#### Service information

Reference no.: SDA\_84870

Water or Steam leaking from Rinse tank interface during normal ironing usage

Applicable for GC9020, GC9040 and GC9140

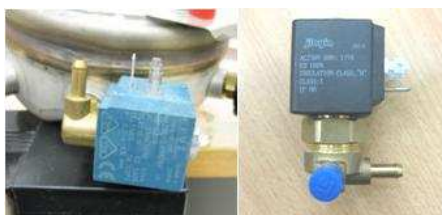
**Symptom:** Water or Steam leaking from Rinse tank interface during normal ironing usage (e.g. not Auto Calc Clean operation)

When rinse valve is unable to seal properly, unit will leak water and steam during heating up of the steam generator.

**Cure:** Replace CEME e-valve with Jiayin valve  
Electrovalve (90 deg) - diagraphm 4239 017 11581

Electrovalve Mesh - diagraphm 4239 010 11101 (same original mesh can be used, replaced if damaged)
